| Ref:             | NR/L2/ELP/27009/MOD C22 |

| OVERHEAD LINE CAMPAIGN CHANGES – DATA SHEET |                                                                                                                                                                                                                                                                                                                                                                                                                                             |
| <b>22</b>                                   | <b>FOULING OF DEEP CURVED STEADY ARM ANTI-WIND STIRRUPS / PROTECTIVE SADDLES</b>                                                                                                                                                                                                                                                                                                                                                            |

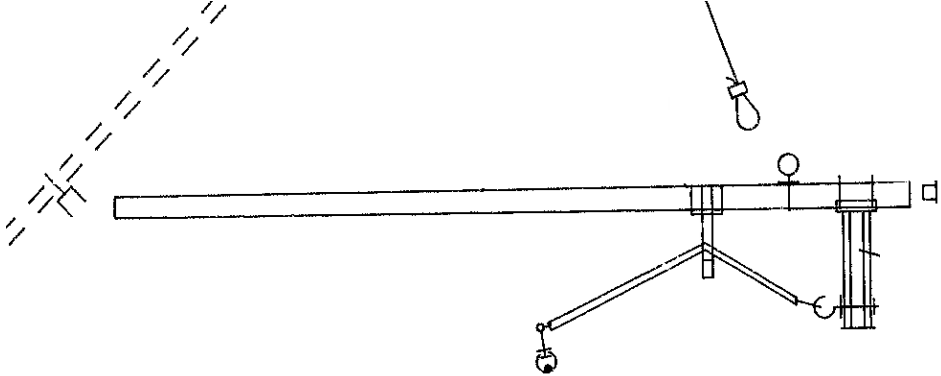
| OVERHEAD LINE CAMPAIGN CHANGES – DATA SHEET |                                                                                                                                                                                                                                                                                                                                                                                                                                             |
|---------------------------------------------|---------------------------------------------------------------------------------------------------------------------------------------------------------------------------------------------------------------------------------------------------------------------------------------------------------------------------------------------------------------------------------------------------------------------------------------------|
| <b>PROBLEM</b>                              | <p>These stirrups were fitted as an alternative design to windstay droppers in high speed registrations subject to large uplift. However the protective saddle moves along the registration tube and fouls the stirrup, causing the steady arm to stick in the uplifted position.</p>  <p>Stirrup and protective saddle. 123/086/001-004 143/155/001</p> |

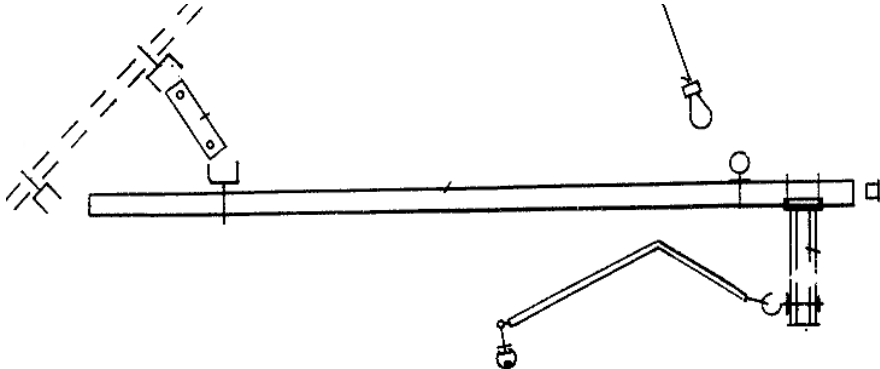
| OVERHEAD LINE CAMPAIGN CHANGES – DATA SHEET |                                                                                                                                                                                                                                                                              |
|---------------------------------------------|------------------------------------------------------------------------------------------------------------------------------------------------------------------------------------------------------------------------------------------------------------------------------|
| <b>ACTION REQUIRED</b>                      | <p>1. Remove the anti-wind stirrup assembly and and fit a registration tube link assembly. See drawing 199/472.</p>  <p>Remove stirrup and fit brace link. 123/086/001-004 143/155/001</p> |
